Collier County

Development Services Advisory Committee Utility Subcommittee

1. Call to order - Chairman.
2. Approval of Agenda
3. New Business
 - a. Revision to the Utilities Standard Manual
4. Old Business
5. Public Speakers
6. Adjourn

Item	Sub-Section I Detail	Revision Summary	Fiscal Impact of change to Developer (Approx.)
Introduction			
1	Introduction	Modified third paragraph to 'introduction' explaining PE responsibilities. Web page reference change.	None
Section 1 – Design Criteria			
2	Cover Page	Web page reference change.	None
3	Table of Contents	Modified Table of Contents to reflect changes and correct scrivener's errors.	None
4	3.3 Wastewater pump stations	Revised section 3.3 Wastewater Pump Stations. Added section 3.3.1 Private Pump Stations.	None
Section 2 - Technical Specifications			
5	Cover Page	Web page reference change.	None
6	Table of Contents	Modified Table of Contents to reflect changes.	None
7	017839 Project Record Documents	Corrected scrivener's error on paragraph 1.3.C. Added notes m and n to part (3.2 B.6) identifying that m) meter boxes and n) Locations of direct bury, conduits, handholes, junction boxes and vaults for buried electric and communication c

**COMMUNITY PUMP STATION CONTROL PANEL DETAIL
VFD STATION WITH GENERATOR**

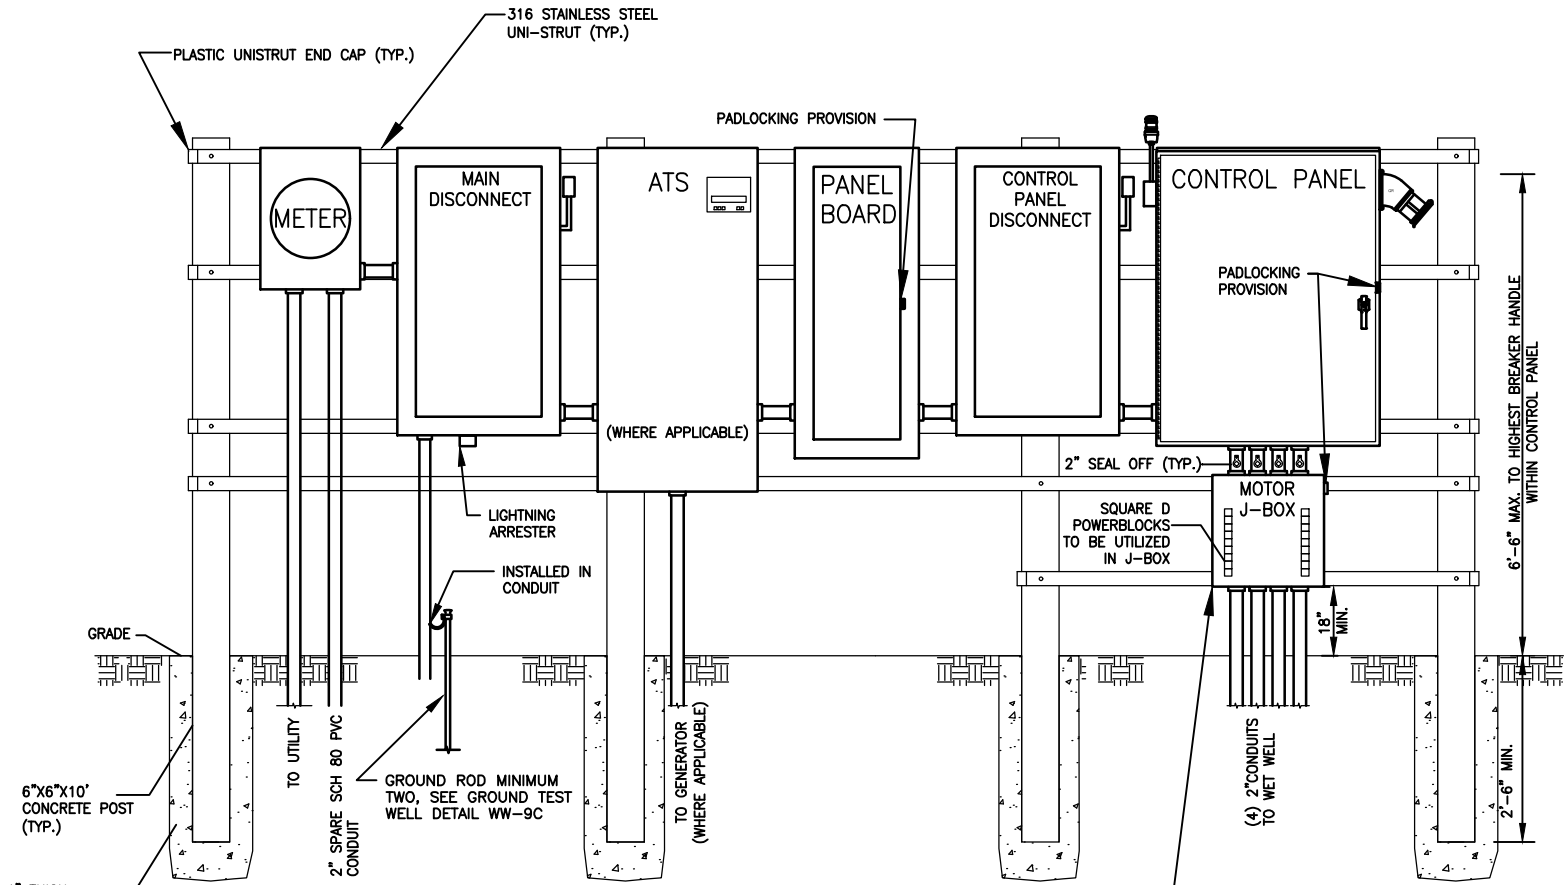
Item	Sub-Section I Detail	Revision Summary	Fiscal Impact of change to Developer (Approx.)
84	WW-9A Community Pump Station Control Panel Detail VFD Station with Generator	An additional concrete post graphic was added to the panel.	Approx. \$500
85	WW-9A Community Pump Station Control Panel Detail VFD Station with Generator	Added callout to detail: 'Square D Powerblocks to be utilized in j-box'.	\$50/pump station
86	WW-9A Community Pump Station Control Panel Detail VFD Station with Generator	Note # 8 was added: "Side panel penetrations are acceptable with the use of Myers Hubs"	\$250.00/Hub (Only used when necessary)
87	WW-9A Community Pump Station Control Panel Detail VFD Station with Generator	Note # 9 was added: "Phase monitor to be installed parallel with FPL meter (on FPL side)".	\$100-\$350/Monitor (Prices vary with voltages)
88	WW-9A Community Pump Station Control Panel Detail VFD Station with Generator	Note # 10 was added: "CHICO used to seal-off in explosion proof fittings under J-box, putty for all other conduit openings". Updated detail to show fittings under control panel.	\$50/pump station

89	WW-9A Community Pump Station Control Panel Detail VFD Station with Generator	Note # 11 was added: "Add emergency stop for generator and fire extinguisher on post furthest from generator with appropriate signage".	Fire Extinguisher Class C – Approx. \$500
90	WW-9A Community Pump Station Control Panel Detail VFD Station with Generator	Note # 12 was added: "All uni-struts to be mounted flush with post and penetrate post with stainless steel hardware"	None
91	WW-9A Community Pump Station Control Panel Detail VFD Station with Generator	Note # 13 was added: "All mounted equipment must be evenly spaced, level, plumb, and installed in a workmanlike manner".	None

Item	Sub-Section I Detail	Revision Summary	Fiscal Impact of change to Developer (Approx.)
92	WW-9A Community Pump Station Control Panel Detail VFD Station with Generator	Pump controls conduit graphic brought forward 'in front of' panel controls conduit on detail.	None
93	WW-9B Community Pump Station Control Panel Detail Non-VFD Station with Generator	Note # 3 was modified by adding the sentence "Single door panels to open away from wetwell".	None
94	WW-9B Community Pump Station Control Panel Detail Non-VFD Station with Generator	An additional concrete post graphic was added to the panel.	Approx. \$500
95	WW-9B Community Pump Station Control Panel Detail Non-VFD Station with Generator	Added callout to detail: 'Square D Powerblocks to be utilized in j-box'.	\$50/pump station
96	WW-9B Community Pump Station Control Panel Detail Non-VFD Station with Generator	Note # 8 was added: "Side panel penetrations are acceptable with the use of Myers Hubs"	\$250.00/Hub (Only used when necessary)
